U.S. Environmental Protection Agency, Region 4
61 Forsyth Street SW, Atlanta, GA 30303
Water Compliance Inspection Checklist

NPDES ID: ALG850067	Effective Date: 12/04/2023	Expiration Date: 05/31/2027
Facility Name: Sardine Pit North		SIC Code: 1442
Address: Alger Road Flomaton, AL 36441		
Mail: 8 East Quintette Road, Cantonment, FL 32533		
On-Site Representatives: Michael Campbell – Owner, American Concrete Supply Scott Campbell – Vice President, American Concrete Supply Paul Bell – Site Manager, American Concrete Supply Ben White – Tensaw Engineering Neil Johnston – Attorney Sean O’Toole – Biome		Responsible Official, Title, Phone Number, Mailing Address: Scott Campbell – Vice President scott.campbell@acs-office.com (850) 968-1515

ALG850000 – Alabama NPDES General Permit for Non-Coal/Non-Metallic Aggregate Mining Worksheet

Image 1

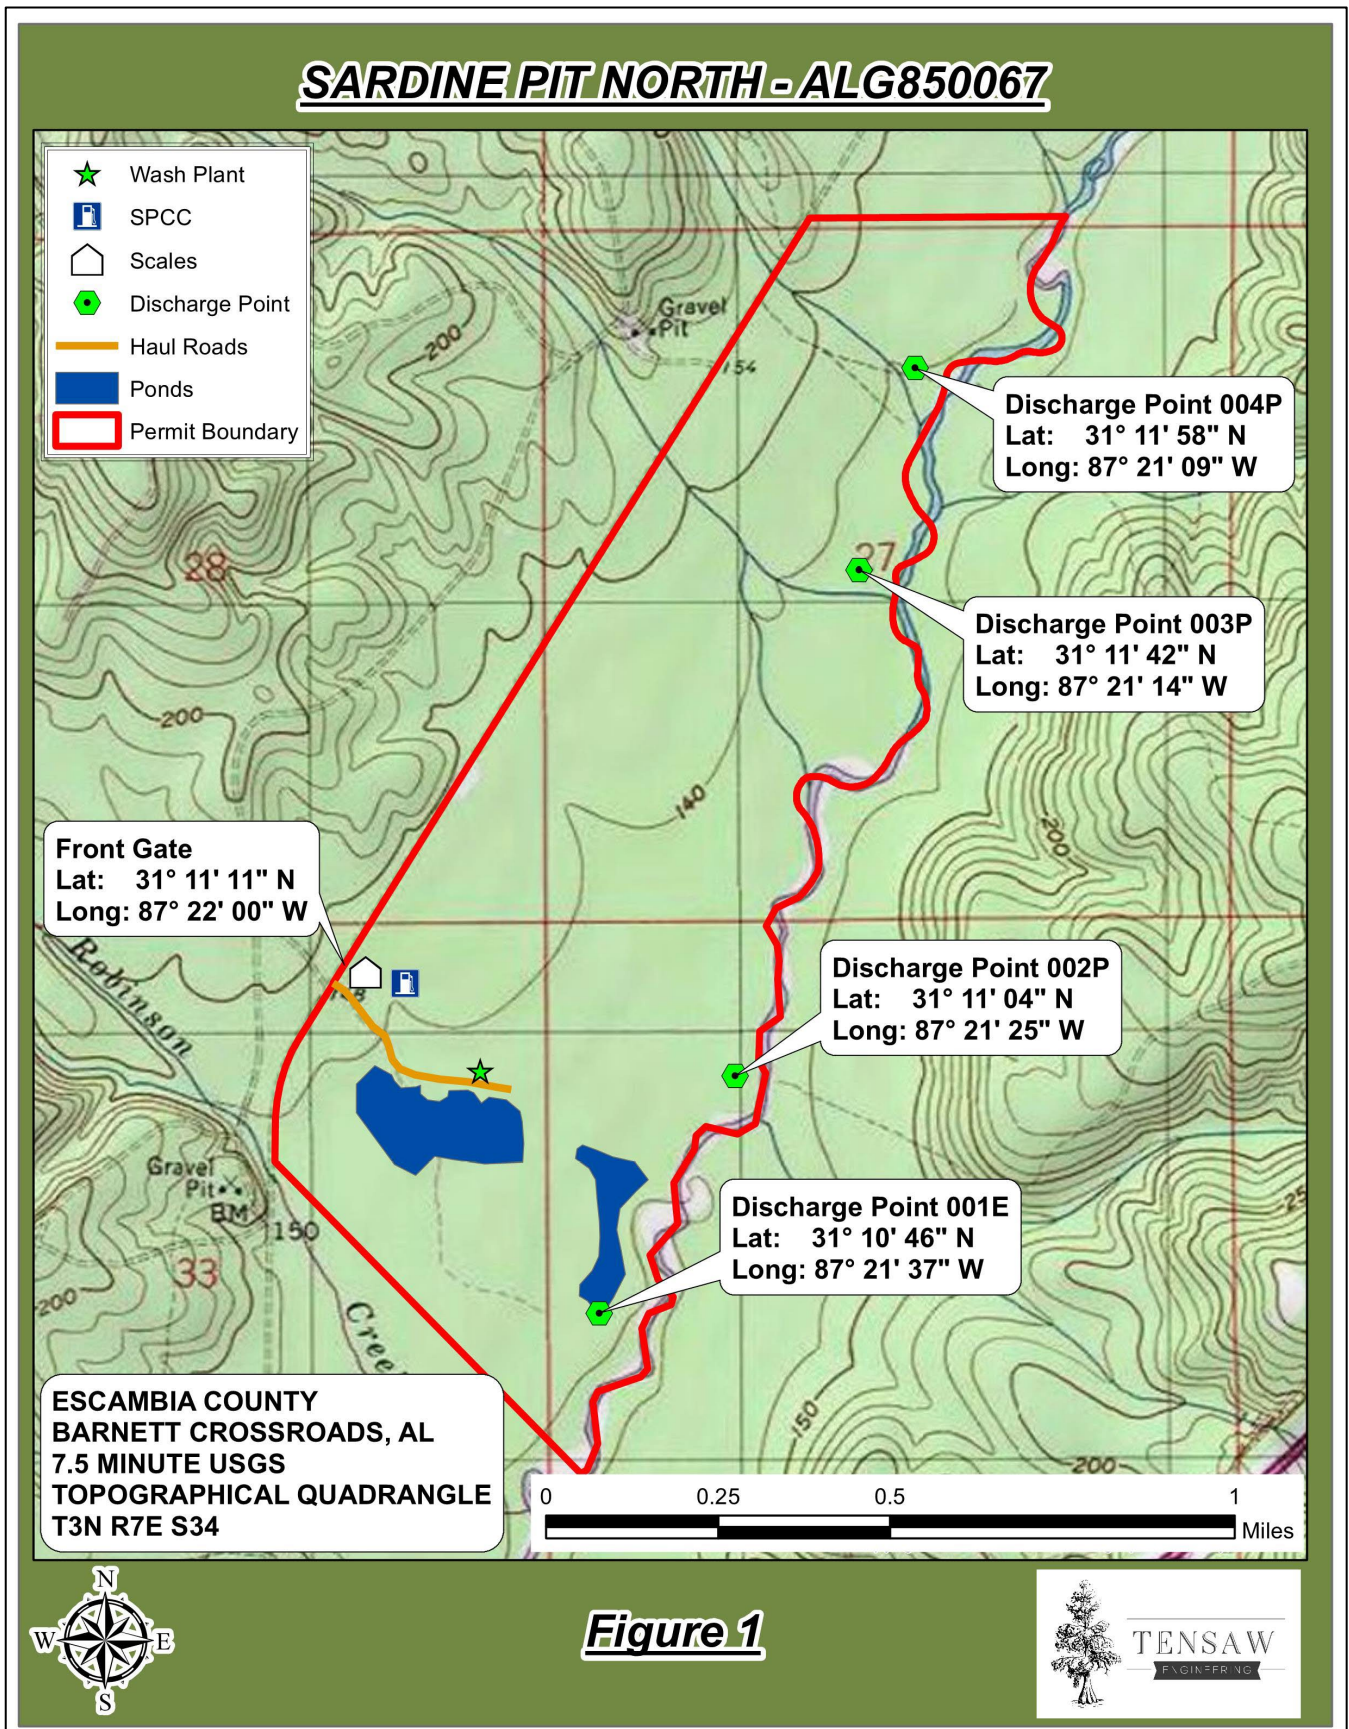
Sardine Pit North (the Facility) is a sand and gravel mine operated by South Alabama Materials. The Facility is bordered by Big Escambia Creek to the East and Robinson Creek to the south (refer to [Image 1](#), below). The Facility is approximately 550 acres in total size with approximately 50 acres of disturbed area at any time. Sardine Pit South and Sardine Pit North comprise the entire 550 acres owned by South Alabama Materials. The Facility originally obtained NPDES permit coverage in 2014 and the permit was renewed in 2017. The Facility’s 2017 permit coverage expired on March 31, 2022, and was not renewed until December 4, 2023.

Image 2

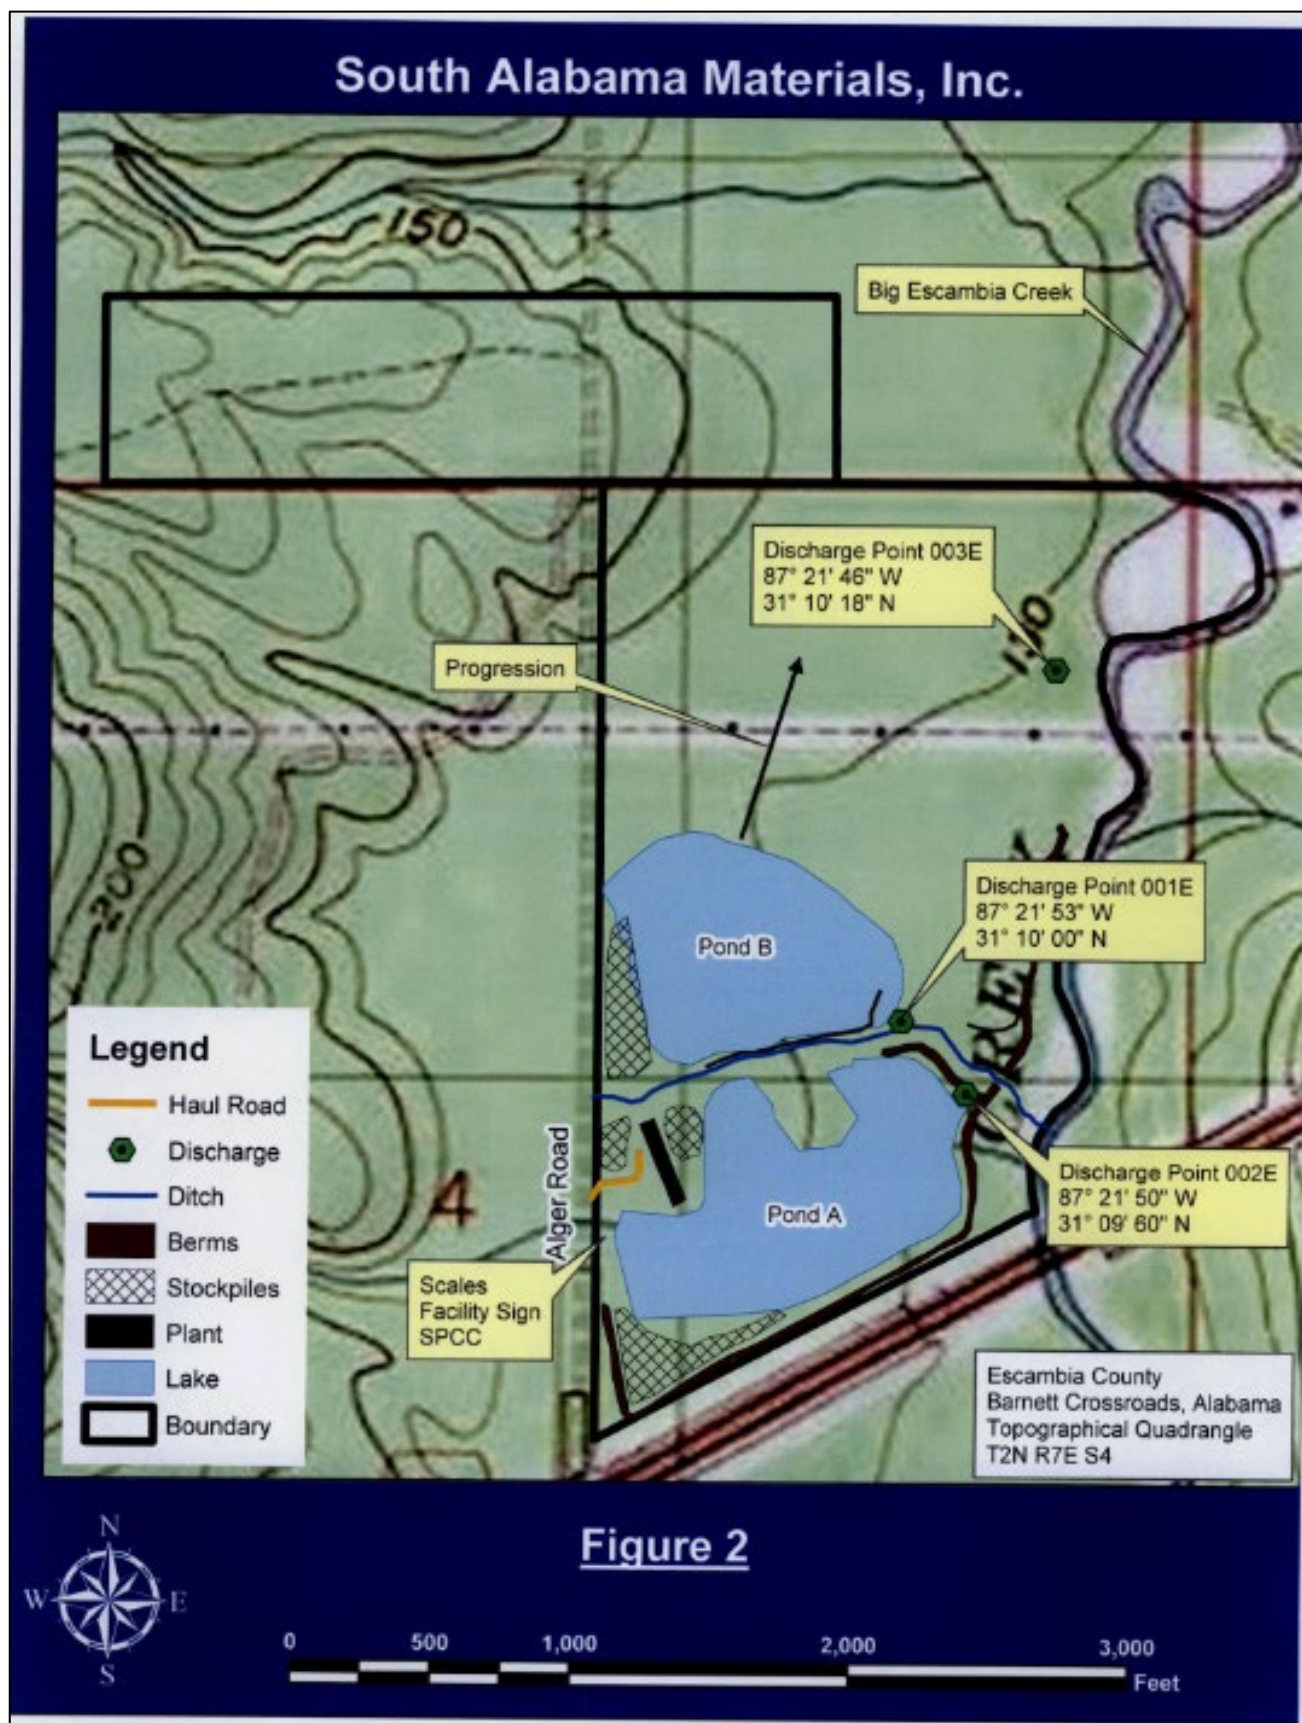
The permittee started Facility mining operations in Sardine Pit South (Permit # AL850066), located south of Robinson Creek (refer to [Image 2](#), below). Mining operations in Sardine Pit South began in approximately 2003 and ceased in 2015, according to the Facility representatives. Following mining operations, the Sardine Pit South was reportedly reclaimed through revegetation. Although operations ceased at Sardine Pit South in 2015, the operator submitted discharge monitoring reports (DMRs) for three outfalls through June 2022, reporting no discharge on all DMRs during this period. Alabama Department of Environmental Management (ADEM) administratively closed out the operations at Sardine Pit South site on July 12, 2022.
